## Specific Design Plan Departure from Parking and Loading Spaces Timothy Branch - Allora Crossing

**SDP-1701-04**  
**DPLS-477**

STAFF REPORT

SUBJECT:        Specific Design Plan SDP-1701-04  
                  Departure from Parking and Loading Spaces DPLS-477  
                  Type 2 Tree Conservation Plan TCP2-068-93-06  
                  Timothy Branch - Allora Crossing

**Figure 1: Site Layout**

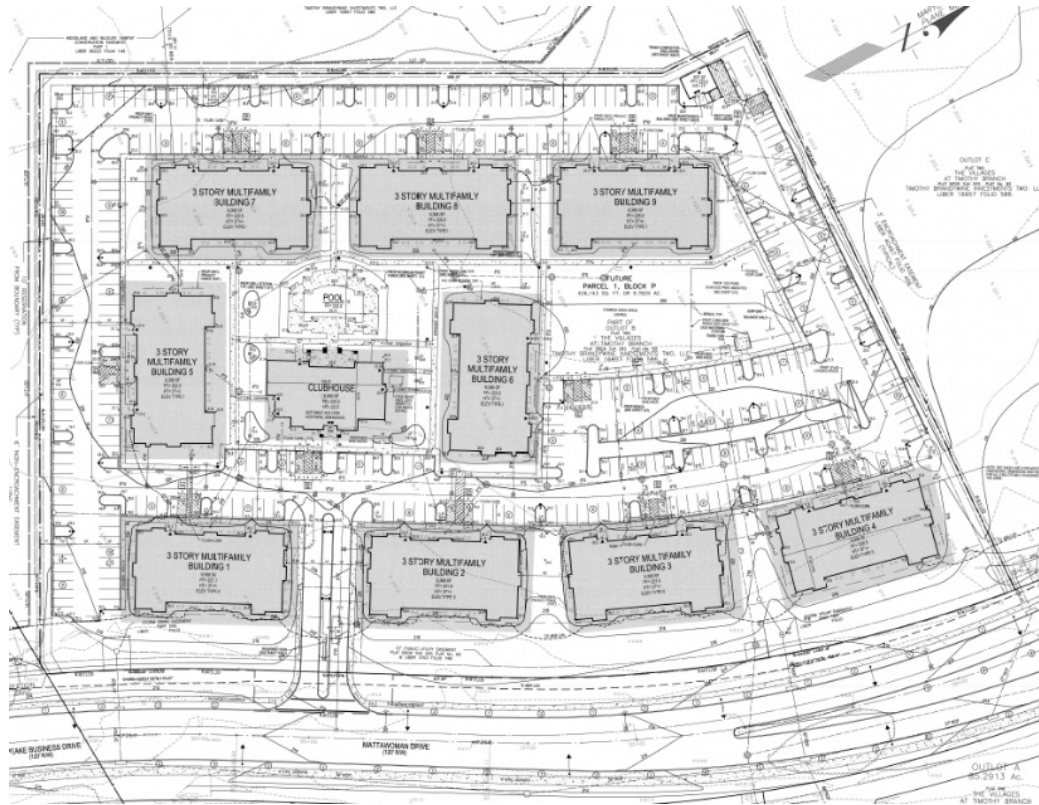
The proposed development consists of nine residential apartment buildings, a centrally located clubhouse and recreational features, a maintenance shed, and associated site features. The layout of the site provides Buildings 1 through 4 adjacent to, and oriented parallel to Mattawoman Drive. Interior to the south-central portion of the site, is a clubhouse and pool complex, with Buildings 5 and 6 located to its south and north respectively, and Buildings 7 and 8 sited to the west of the pool. Building 9 is in the northwestern portion of the site, north of Building 8, with a dog park and open space provided to its east. A single driveway with a median connects to Mattawoman Drive at the southeast corner of the site, between Buildings 1 and 2. The location of the driveway will provide those entering the site with a view of the clubhouse. Parking lots wrap the

southern, western, and northern perimeter of the site, with additional parking shown through the east-central portion of the site. DPLS-477 has been requested to reduce the number of parking spaces normally required for the development. A small maintenance building is provided in the northwest corner of the property adjacent to a trash enclosure. Sidewalks are provided internal to the site and connecting to the sidewalk on the west side of Mattawoman Drive.
